Temporary Change T-1 to Technical Manual for AN/SRT-14,-15, and 16, NAVSHIPS 0967-970-3010 (Formerly NAVSHIPS 92121A).

TEMPORARY CHANGE T-11 to TECHNICAL MANUAL w/change 1 for  
Radio Transmitting Sets AN/SRT-14, -14A thru-16, 16A,  
NAVSHIPS 0967-073-4010 (Formerly NAVSHIPS 92121A).

TEMPORARY CHANGE T-10 to TECHNICAL MANUAL for Radio Transmitting Sets AN/SRT-14, -14A, -15, -15A, -16, -16A NAVSHIPS 0967-073-4010 (Formerly NAVSHIPS 92121A).

Figure 1

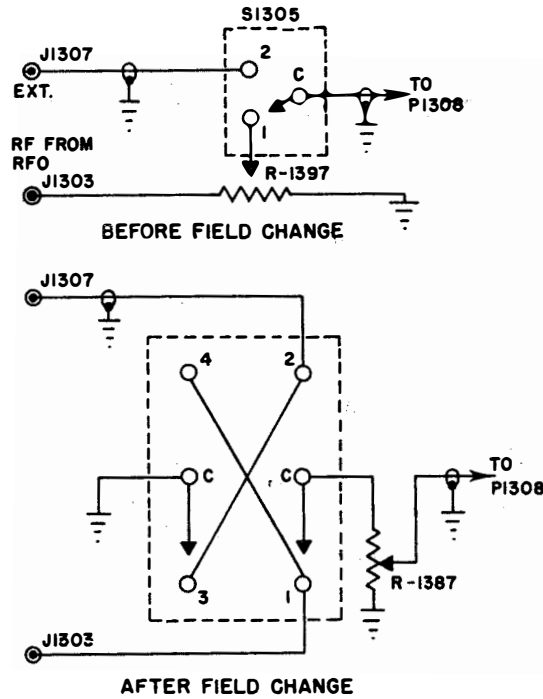
- a. Figure 7-159. Radio Frequency Amplifier AM-1008/SRT(RFA) wiring diagram (sheet 2 of 2). With pen and ink change the diagram to show DPDT switch instead of SPDT switch S-1305 and show connections in accordance with figure 1 of this correction.

1. Figure 7-159. Radio Frequency Amplifier AM-1008/SRT (RFA), wiring diagram (sheet 2 of 2). With pen and ink change the diagram to show DPDTswitch instead of SPDT switch S-1305 and show connections in accordance with figure 1.

Figure 2. Pictorial Wiring Diagram

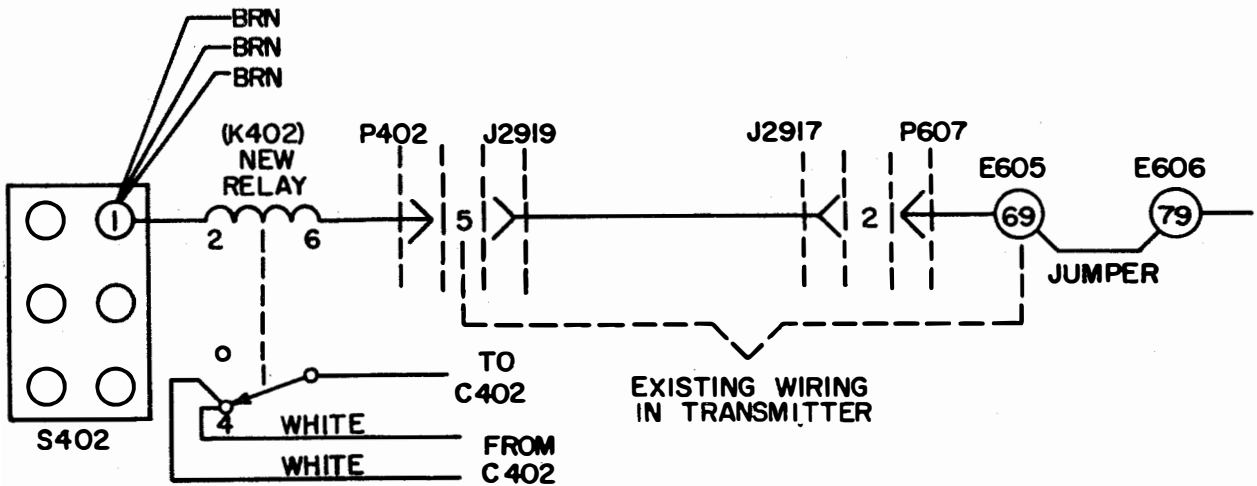
a. Figure 7-151. Control-Indicator C-1352/SRT, Schematic Diagram. Draw a diagram in the blank space directly below M-401 showing the new relay K-402 with connections to S-402, C-402, and P-402-5. See Figure 2.

Figure 3

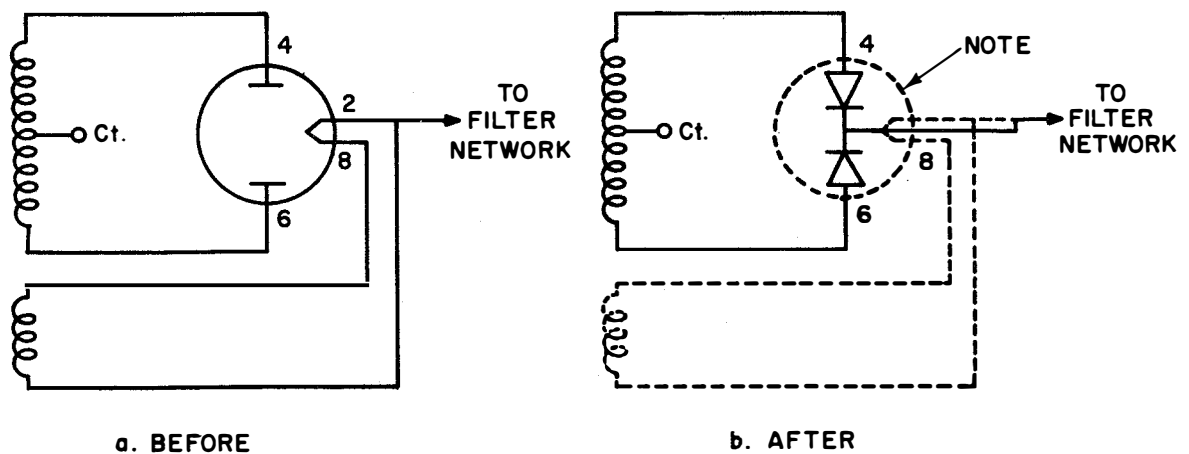
(4) Change tube diagram to diode diagram (see figure 3).

(3) Change Tube diagram to a "Diode diagram" (see figure 3).

(3) Change "Tube diagram" to a "Diode diagram" (see figure 3).

(4) Change the three Tube diagrams to "Diode diagrams" (see figure 3).

Figure 1. Insulating Disk

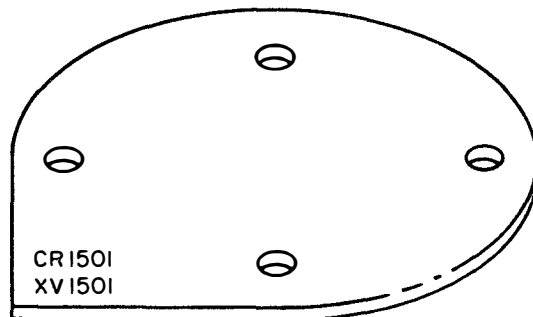
1. Pull out the drawer that contains the high voltage power supply, PP-1096/SRT.
2. Remove the six type 3B28 tubes.
3. Disconnect and remove the High Voltage Cable, which consists of wires 101 through 113, inclusive.
4. Unbolt tube socket XV1501 and remove the tube socket and the accompanying insulating disk. Add item no. 2, the disk marked CR1501, below the old disk. Replace both disks and the tube socket to the original mounting position. Bolt in place. (See figure 1.)

Figure 2. Field Change, Partial Wiring Diagram

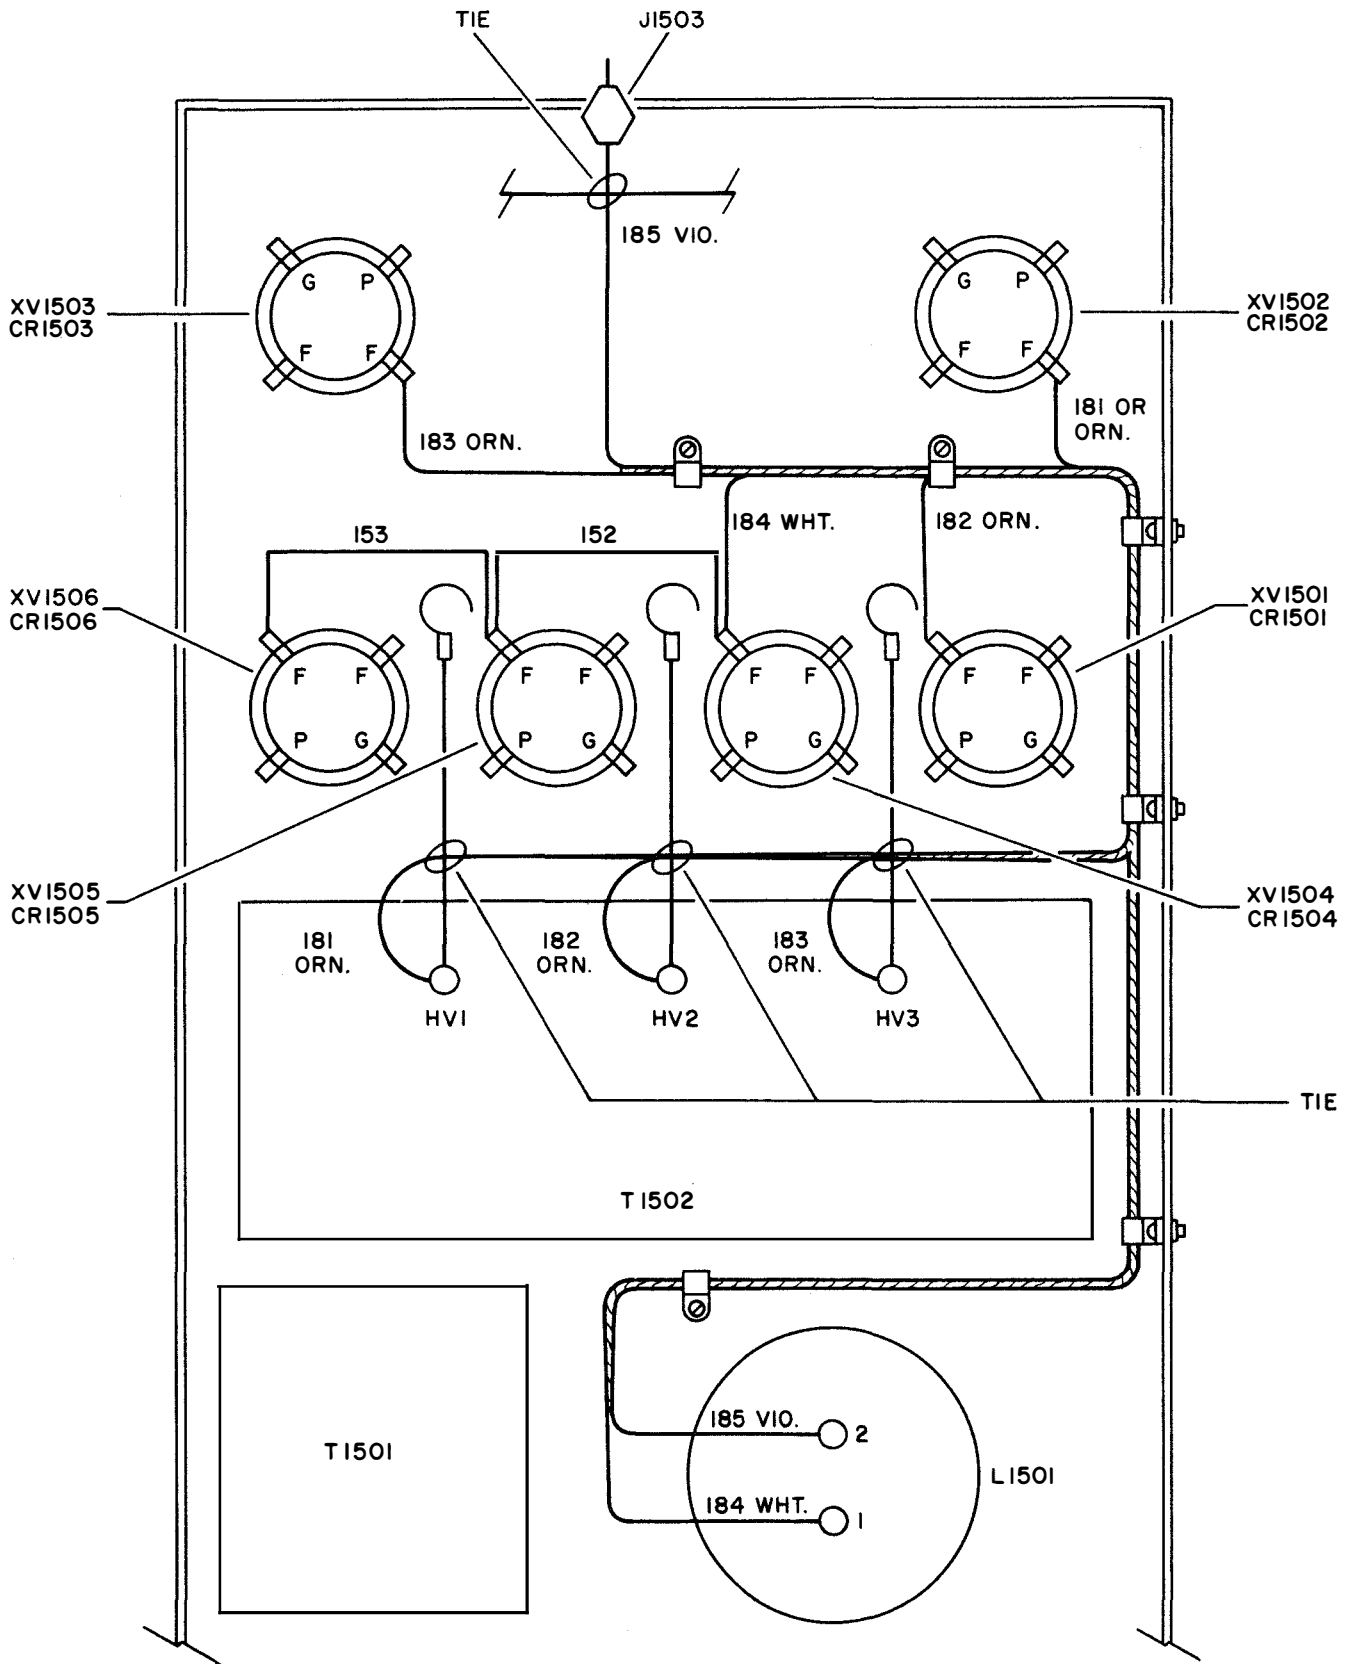
11. Using the supplied solvent (item number 4), remove any of the old tube designations that are visible on the chassis. Spot tie the new high voltage cable, as indicated in figure 2, using the lacing cord supplied.

Figure 1. Buffer and I. P. A. Subassembly, Right Side

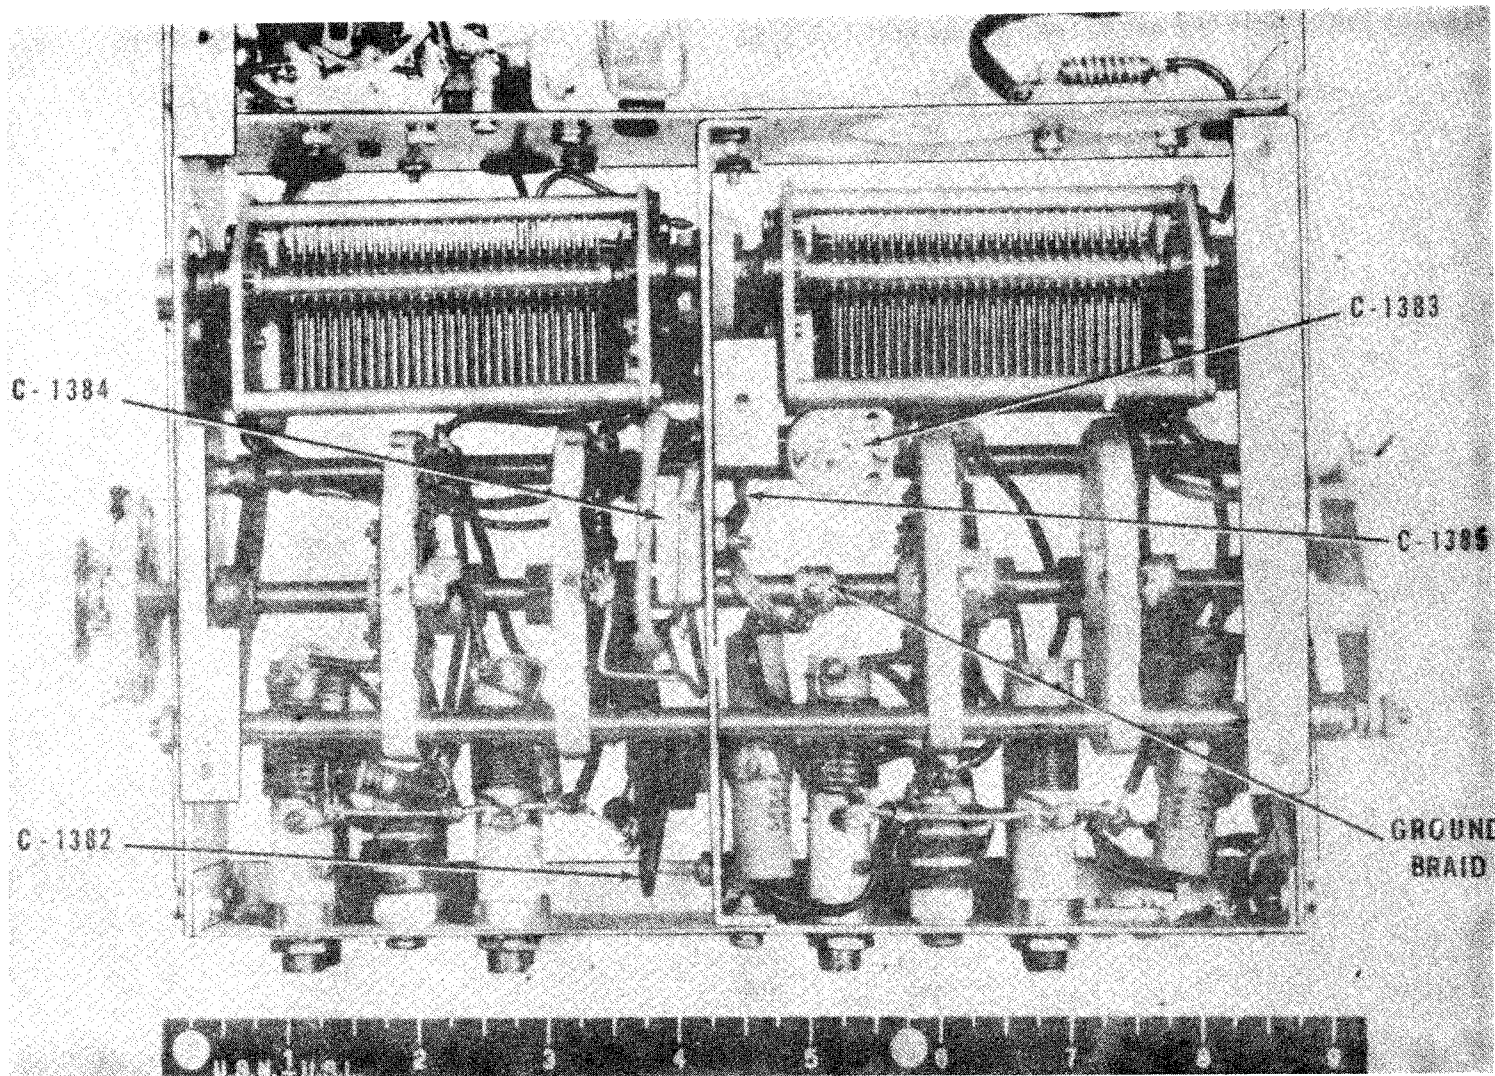
1. Page 2-91, Figure 2-96, Buffer V-1301, Simplified Schematic
  - a. Add R-1398 from S-1305-2 to ground.
  - b. Add R-1704 in parallel with L-1332.
  - c. Add C-1382 from +300 volts side of L-1332 to ground.
2. Page 2-92, Figure 2-97, Buffer Tank Circuit, Simplified Schematic
  - a. Add R-1705 in parallel with L-1306.
  - b. Add C-1383 from +300 volts side of L-1332 to ground.
3. Page 2-92, Figure 2-98, IPA V-1302, Simplified Schematic
  - a. Add C-1382 from cap of V-1302 to junction of C-1306 and L-1302 (Not shown)
  - b. Add C-1383 between cam junction and ground.
  - c. Add R-1705 in parallel with L-1306.
  - c. Add C-1384 in parallel with C-1313 to ground.
4. Page 2-94, Figure 2-99, IPA Tank Circuit Simplified Schematic
  - a. Add R-1705 in parallel with L-1306.
  - b. Add C-1385 in parallel with C-1313 to ground.
5. Page 2-95, Figure 2-100, PA V-1304 Simplified Schematic
